M3300A-01

Modification Recommended Service Note

M3300A PXIe AWG and Digitizer Combination

Serial Numbers: MY57080100 - MY57479999
ES56600101 - ES56600145

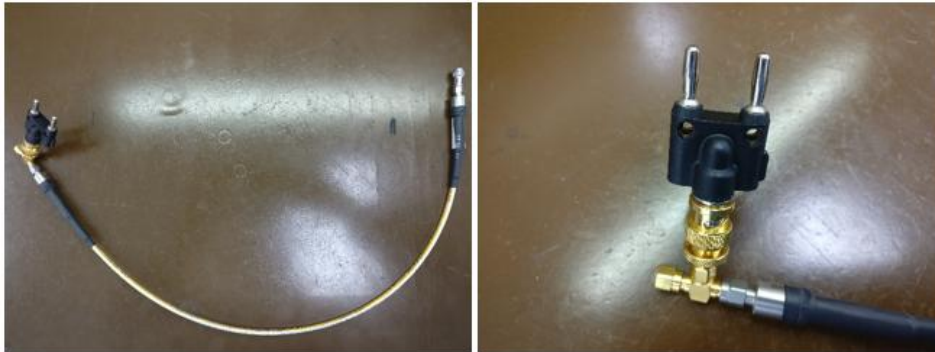
1. A possible short circuit between the filter output pad and the PCB ground plane due to insufficient ground clearance in the PCB design.
1. The performance of the filter changed sometime in 2017 which was not picked up by Keysight. This resulted in unstable DC offset performance after being in operation for some time.

The ground plane clearance problem can be seen below:

These problems have been fixed in all modules, M3201A & M3202A, M3300A & M3302A from MY57510001 onwards.
